CITY OF CONWAY, ARKANSAS PLANNING COMMISSION

June 17, 2024 • 5:30pm • 1111 Main Street

A. Request for preliminary plat approval of Encore Subdivision (SUB-0524-0077)

A. Request to rezone property at 2510 Tyler St from R-1 to PUD (PUD-0424-0053)

STATE PLAT CODE: EXHIBIT DRAWING

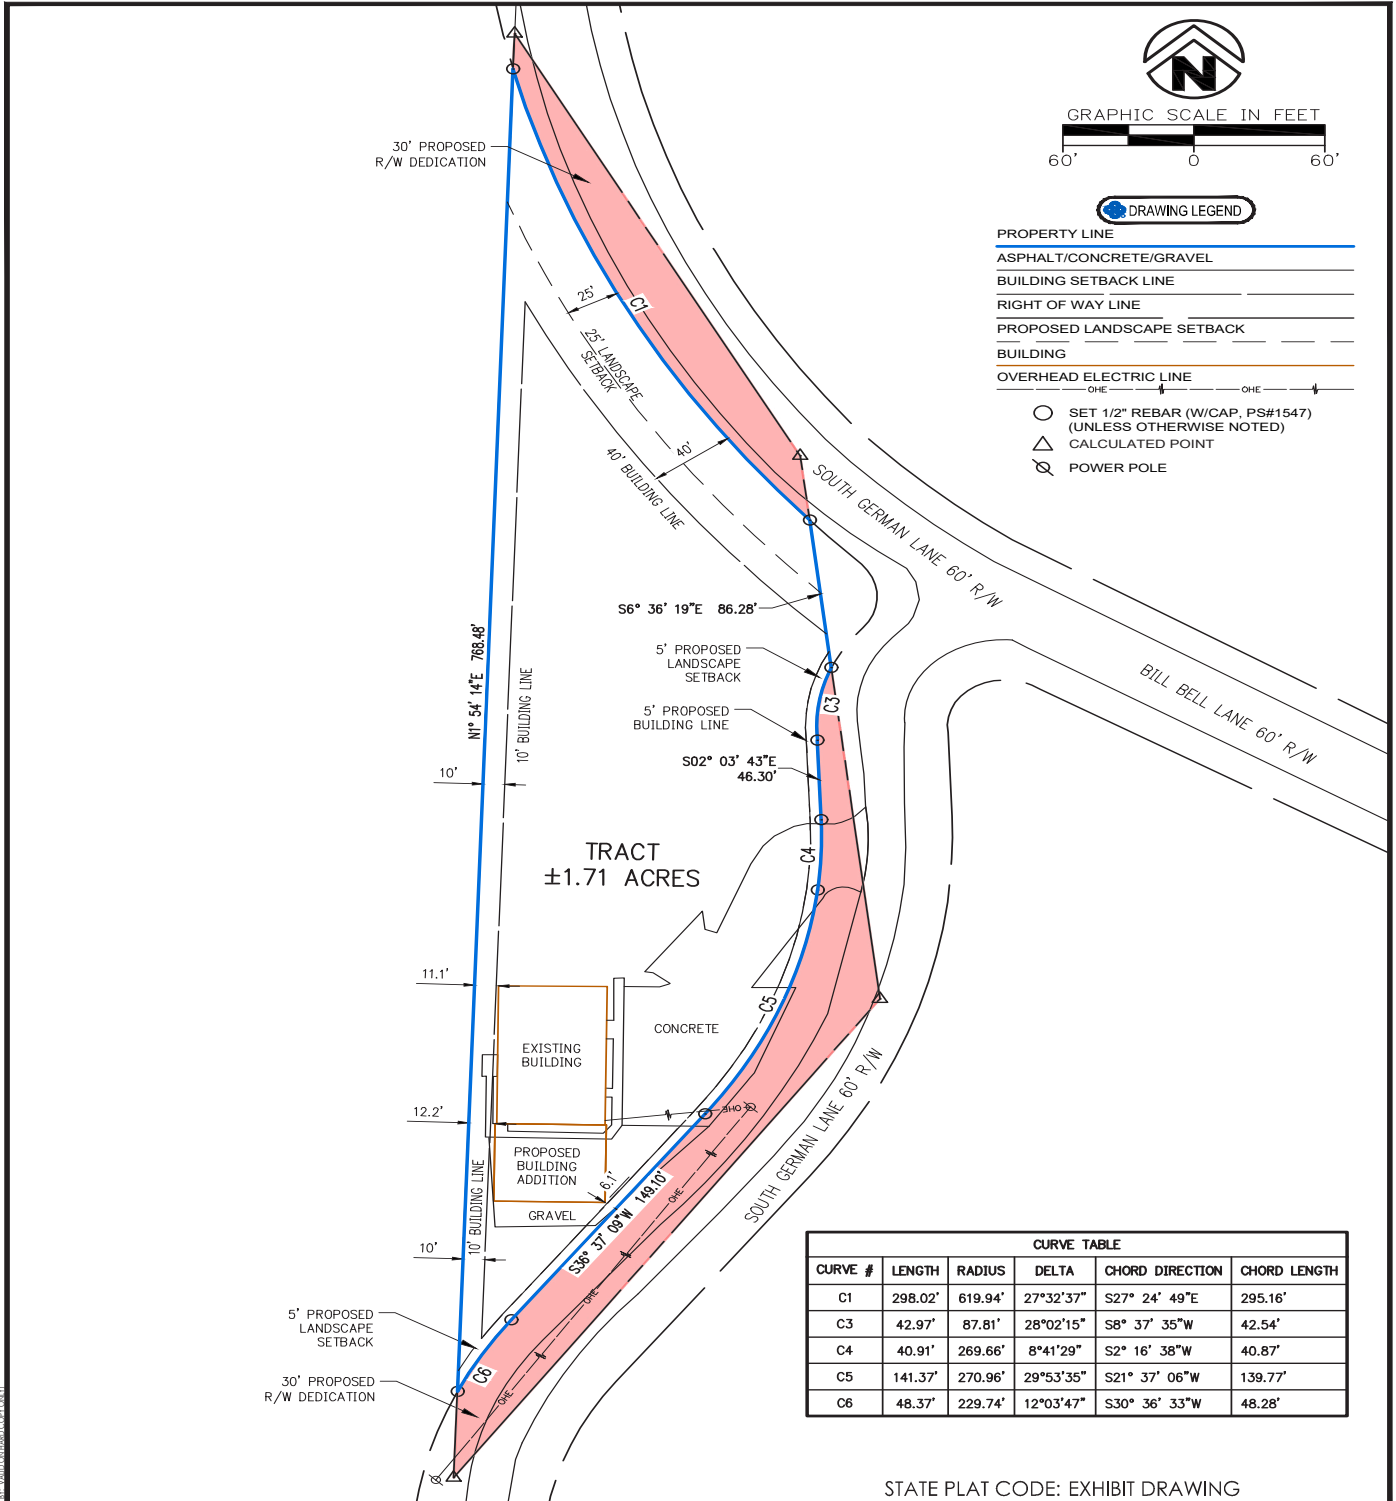
- The constraints to the developable space to the north push all developable areas to the south of the existing structure.
- Due to the surroundings, lot shape, and topographical conditions of the property, the strict application of the Zoning Code would result in an undue hardship to the church for future expansion. With the existing church footprint already having reduced rear setbacks, the granting of a reduced rear setback would be required for the new addition as well.

- To pull appropriate building permits, the applicant will have to undertake site development and subdivision review; platting of the property will require the appropriate amount of right of way dedication along S German Ln (30'). This will dedicate portions of the front setback buildable area including existing parking spaces as well as landscaping area.

- With the front setback reduced from 25', the required 25' front landscaping setback will also have to be reduced. There is already existing parking in the required landscape setback, and staff are requesting to waive that section of the Zoning Code as it only applies to S-1 lots. This parcel is not in a standard lot configuration where enforcing the landscaping buffer is practical.

3. Building setbacks will be established as follows:
 - Front: 6 feet
 - Rear: 10 feet
 - Side: 25 feet
4. The 25' landscape setback requirement as required by the Zoning Code will not be required on the section of property south of the intersection of S German Lane and Bill Bell Lane. The 25' landscaping buffer is required along the S German Ln frontage north of the intersection.

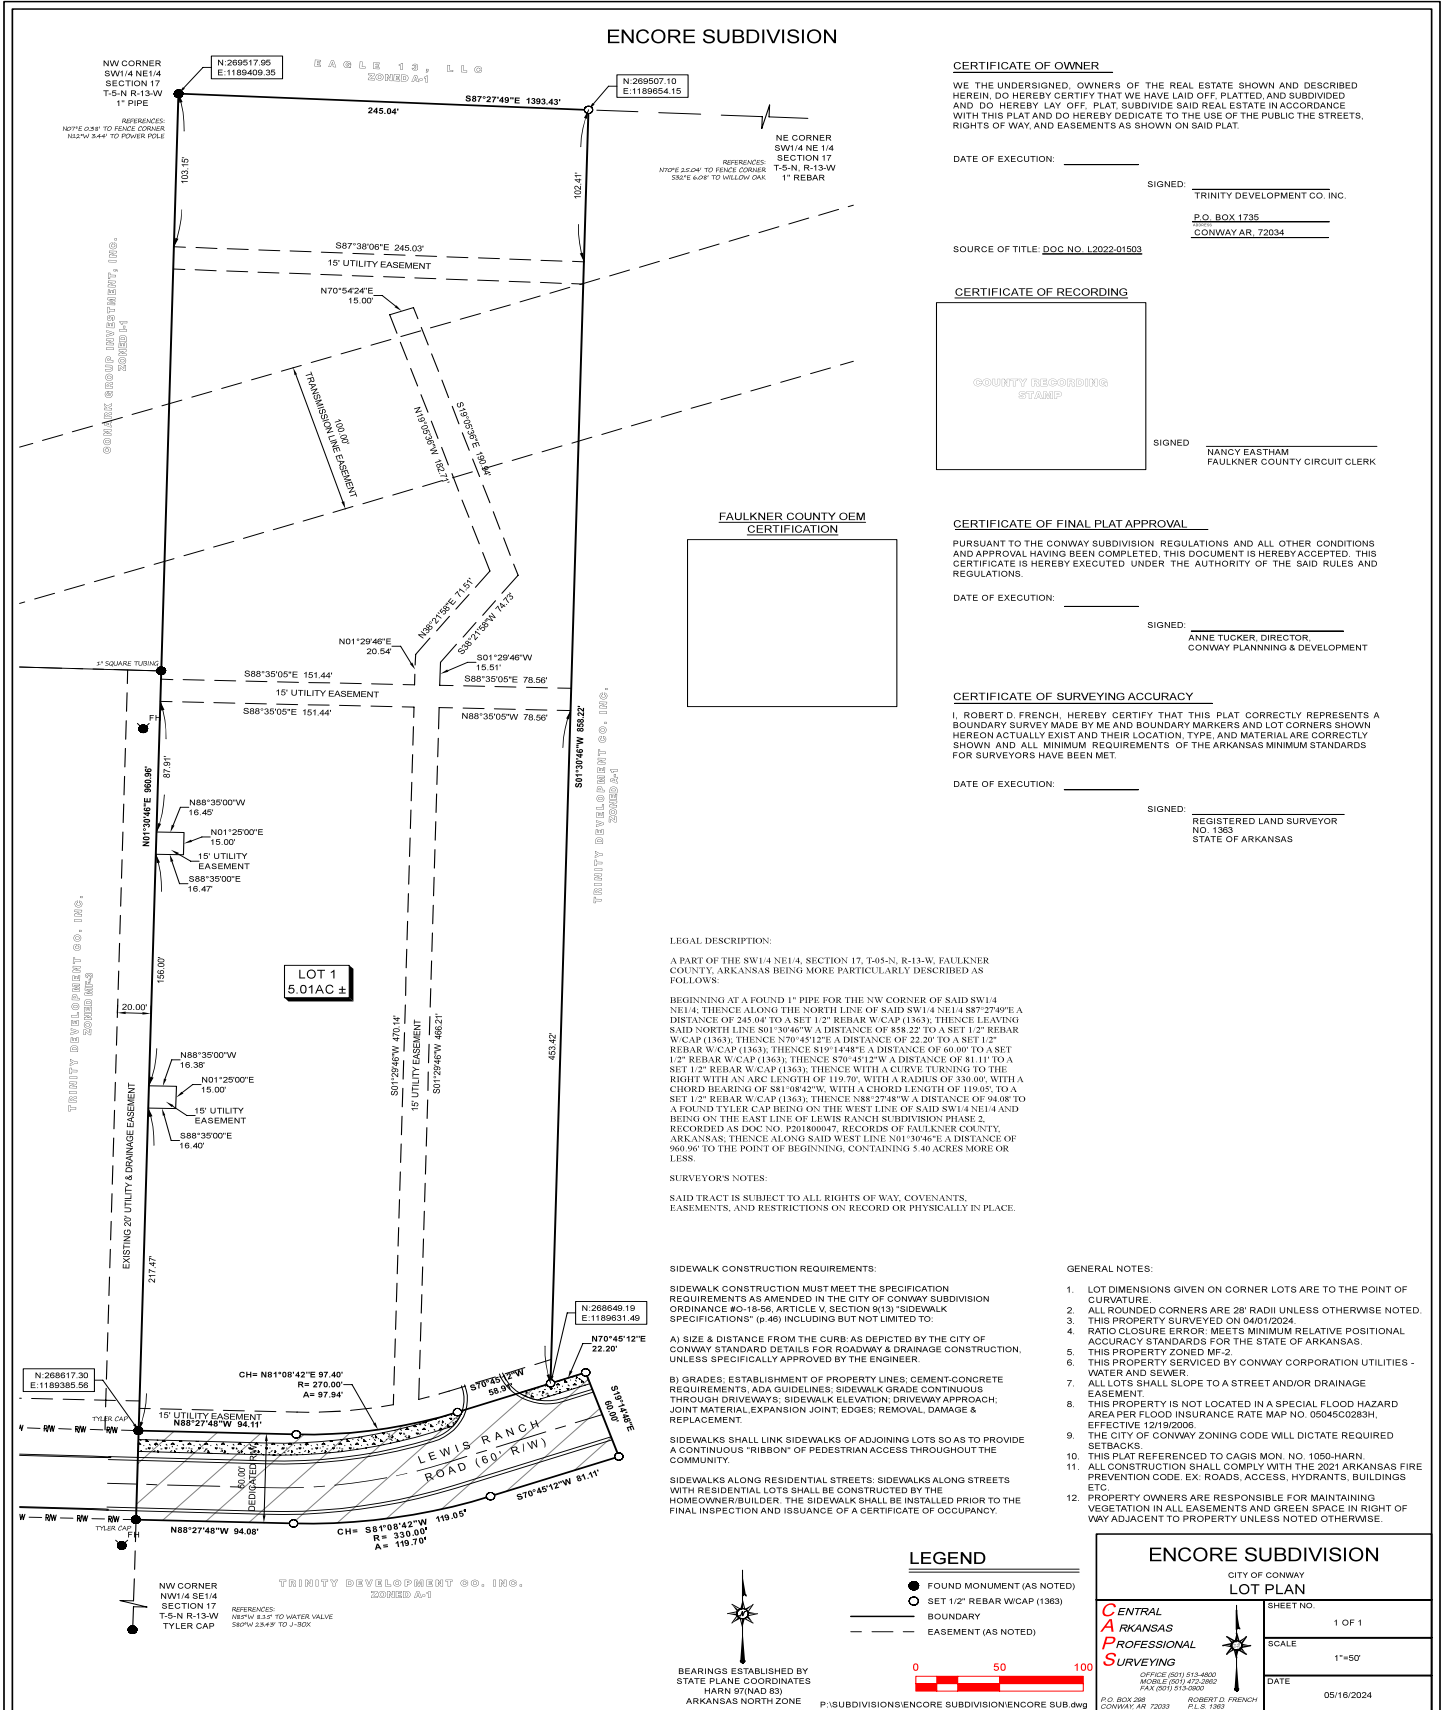
CORRECTIONS NEEDED ON THE PLAT

1. Include vicinity map with acreage.
2. Correct signature line.
3. Provide all easements as indicated by the City Engineer and Conway Corporation.
4. Other corrections as required by the City Engineer, Planning Director, and Conway Corporation on the Preliminary Plat/ Street and Drainage Plans.
